BCA ASSESSMENT REPORT

Lot 5, Oakdale West Estate, Kemps Creek

**Prepared For:
Goodman Property Services (Aust) Pty Ltd**

Project No.: 220055

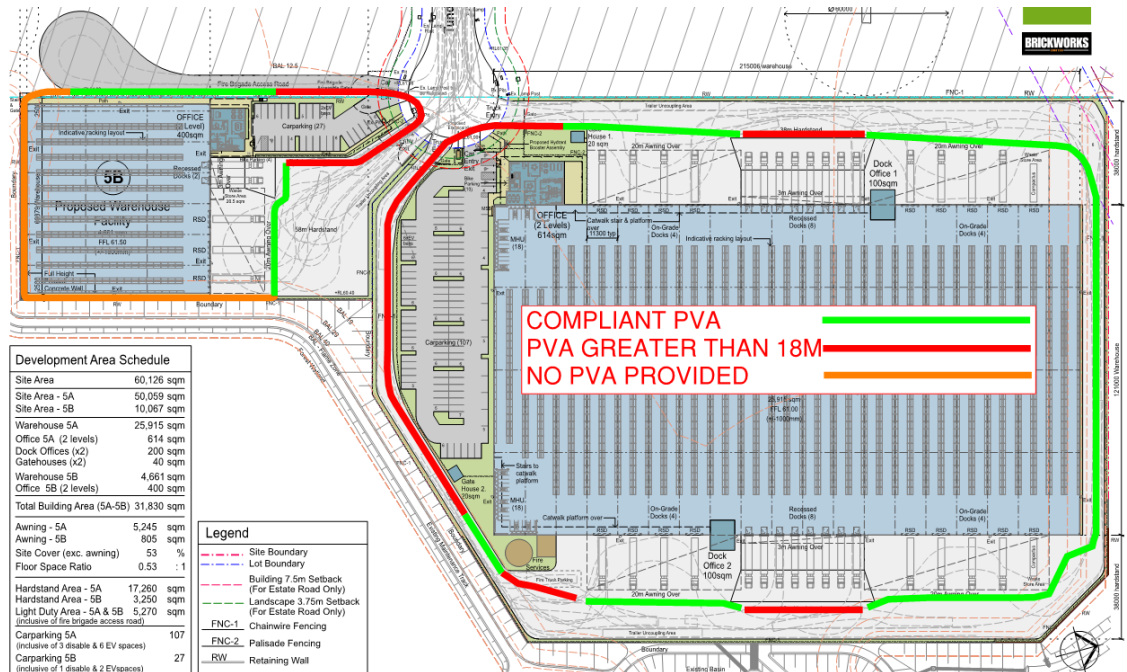
Comments: The proposed buildings do not comply with the provisions of C2.4 and thus the following non-compliance areas are identified on the site plan that are required to be addressed as a Performance Solution by the Fire Safety Engineer for each building:

- + *Site 5A - The furthest part of the vehicular access path is greater than 18m from the external wall on the southern side of the building, the hardstand along the eastern and western walls, and around the south-east fire services.*

- + Site 5B – Perimeter Vehicular Access is not provided to the Southern and Eastern sides of the building.
- + Site 5B – The furthest part of the vehicular access path is greater than 18m from the external wall around the north west corner of the building.

Note: The DtS compliant perimeter vehicular access is shown in green in the mark-up below.
